Product Change Notice (PCN)

Subject: Product Improvement - Transition from projection align to stepper for the HIP4086AW product

Publication Date: 7/6/2018

Appendix A – Wafer Layout Difference

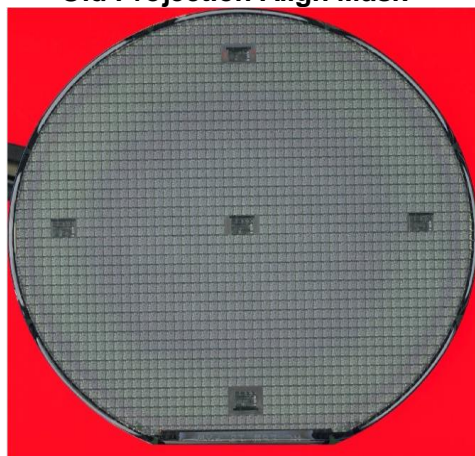
The HIP4086AW product is being converted from a projection alignment tool (Perkin Elmer) to a Canon iW Stepper. There is no change to the design, however, there will be a change to the wafer layout. The die count will effectively increase from 1673 to 1685 with this change. See appendix A.
